RE: Notice of Application Incompleteness

Project Name: Saticoy East Village Commercial Center

Project Number: 10484

Case Number(s): DRC-6-20-55396; PD-6-20-55397; UP-6-20-55398

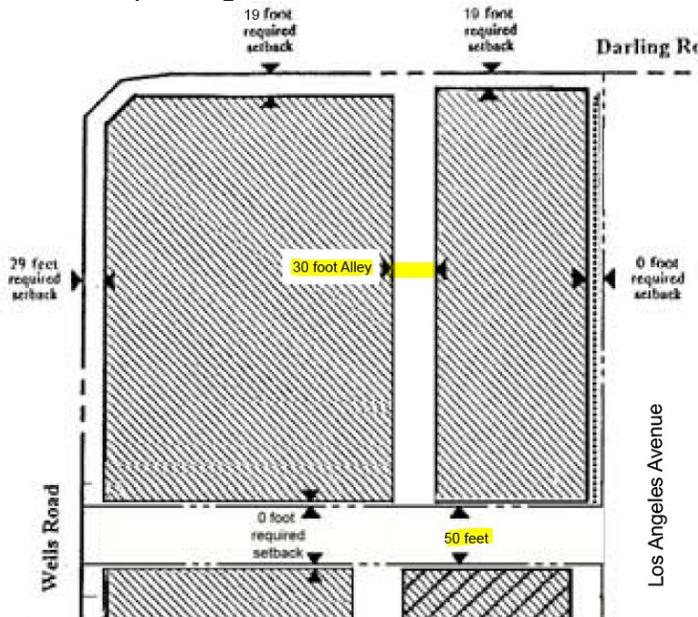
A. The alley between Quad A and Quad B as well as the entirety of B Street is required to be 30 feet wide. However, the entry on Darling Road between the loading area and parking spaces shows 25 feet.

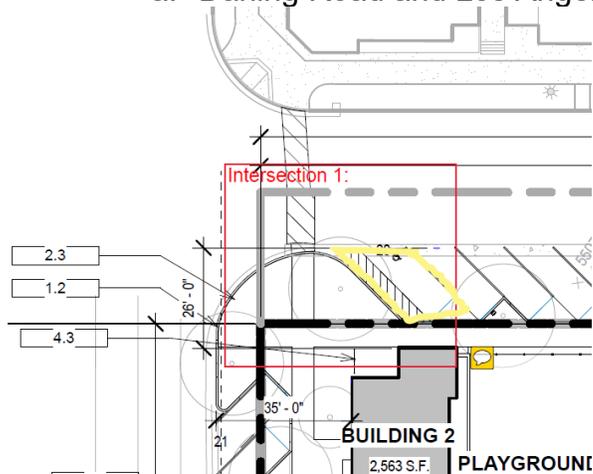
- *Wells Road.* The intersection of Wells Road and Snapdragon shall be designed to physically prohibit left turns out and allow for right turns in and out. Existing Class II bike lanes shall remain and be incorporated into the design of the signing and striping of the project. Minimum sidewalk width shall be 8-feet along Wells Road. The access ramps at the corner of Wells Road and Snapdragon Street shall be constructed as directional ramps since pedestrian crossing of Wells Road will be prohibited.

- *Darling Road.* While Darling Rd is not on the BMP High Priority map, it is identified within the Bike Master Plan recommended improvements. These improvements should be made during this opportunity. Please provide at a minimum, Class 3 route signage and markings. Minimum sidewalk width shall be 8-feet along Darling Road. Angled parking should be back-in for increased bike safety.

- *Easements.* The project shall provide public access easements along the Darling Road and Wells Road frontages that may include sidewalk and on-street parking areas (as applicable). However, maintenance of these areas outside of the Caltrans and City right-of-way shall be the responsibility of the property owner. The dividing line between the public right-of-way and private property shall be clearly delineated (i.e., concrete vs asphalt, clear score lines, or brass inlay with plaque).

a. Darling Road and Los Angeles Avenue

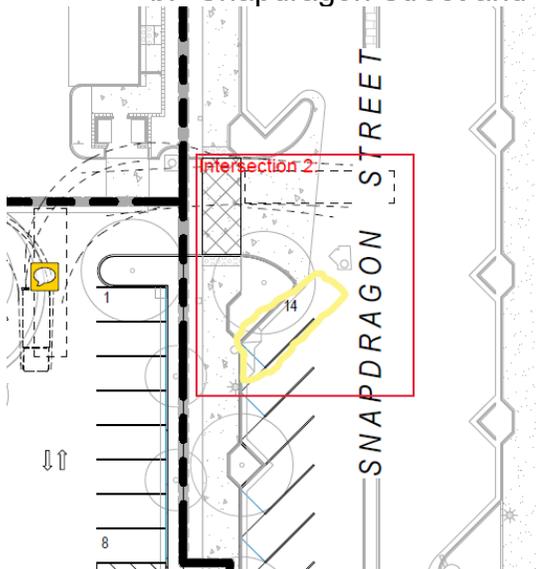
7. Vehicle Circulation. On the site plan, there are three intersections that pose concerns for vehicle safety, parking, and circulation. The corner diagonal parking spaces are located at the intersections with stop signs or ingress and egress. There are visibility and traffic concerns of the vehicles backing out of those parking spaces into oncoming traffic. In some instances, there are large canopy trees planted causing more sight distance issues for potential moving vehicles.

Please provide the backout radius for each of the end parking spaces near the streets. If the line of sight is obstructed or the backout distance interferes with the intersections, those spaces should be removed. The Traffic Study provided also indicates that there are potential site distance issues and queuing conflicts with the parking spaces on Snapdragon that would need to be removed.
